The New Piper Aircraft, Inc.
2926 Piper Drive
Vero Beach, Florida, U.S.A. 32960

SERVICE No. 990 BULLETIN

Date: January 3, 1996

Pacific Scientific Seat Belt Replacement

FIGURE 1 (Suspect Belts)

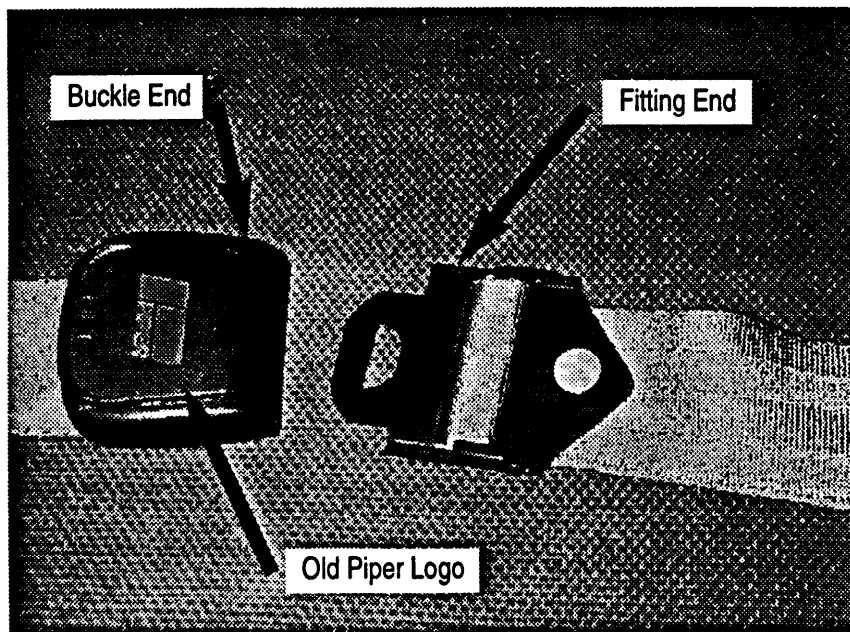
1. Inspect seat belts at each position in the aircraft. If seat belts conform to the information shown on Fig. 3 no further action is necessary. If the seat belt does not conform, proceed to Instruction 2 (see Figures 1 and 2). If parts are not immediately available or should the aircraft need to be flown to an approved service center, the existing seat belts may be utilized provided the pilot in command inspects each seat belt being used for secure positive latching and that the seat belts are free of any anomalies prior to each flight and during each usage.

2. Determine if the aircraft is equipped with the affected seat belts. Seat belts are affected if they are manufactured by Pacific Scientific and the seat belt has a date stamp of 6/94 through 8/95 (See Fig 2), if the seat belt buckle end has an old Piper logo or no logo (See Figs. 1 and 4.), and if the seat belt fitting end I.D. tag has a date stamp of 6/94 through 8/95. (See Fig 2.)
3. Gain access as necessary to remove all affected belts and replace with new. All improved seat belts will have The New Piper Aircraft, Inc. logo on the buckle end. (See Figs. 3 and 4.) All improved seat belt fitting ends will also have a date stamp on the I.D. tag of 9/95 or later.
